# **Staff Report**

### **Knoxville Historic Zoning Commission**

File Number: 6-C-24-HZ

Location:1708 Highland Ave.Parcel ID94 N L 013District:Ft. Sanders NC

| Owner<br>roject Name |                | CENTERLINE OF RIGHT-OF-WAY            |  |
|----------------------|----------------|---------------------------------------|--|
| SITE PLAN            | SIT            |                                       |  |

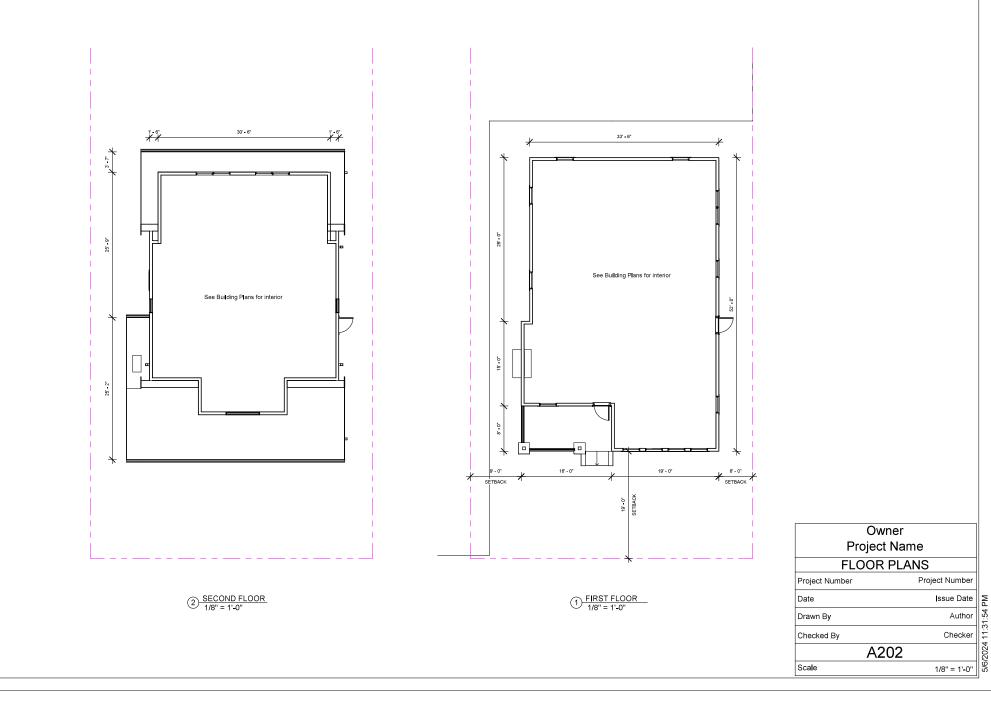
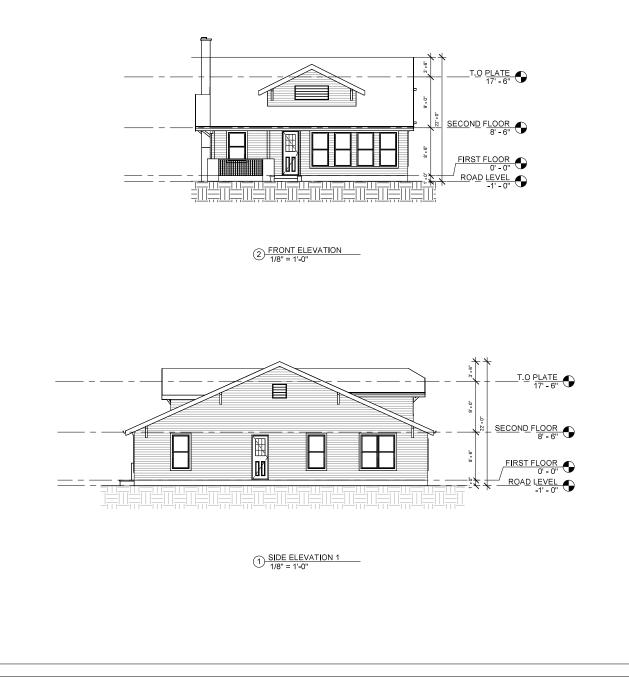
6. Final modifications to the site plan will be necessary to meet City Engineering standards for parking. The house and parking area should remain within the impervious surface requirements for the base zoning. The final site plan could be approved by staff, provided there are no substantial modifications to the addition's design and placement.

3) final site plan to meet City Engineering standards and requirements of the base zoning.
